RECALL 17V-328: E65/E66 (7 SERIES) DOOR LATCHES

This Service Information bulletin supersedes SI B51 24 17 dated June 2018

RE: Recall 17V-328: Door Latches

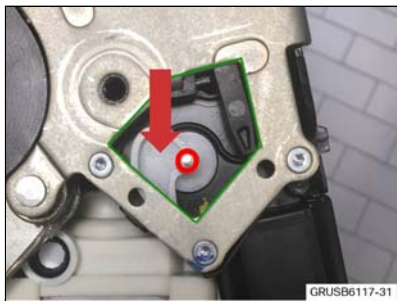
5. Once the door lock is removed, modify each lock by removing the white or yellow opening assist cam (red arrow).
6. If the door lock is replaced modify the new door lock as outlined below

7. Manually position the cam so that it is clearly visible in the opening.

8. Cut the head of the cam retainer off with a pair of cutters.

9. Slide the cam off and discard using a pair of needle nose vice grips.
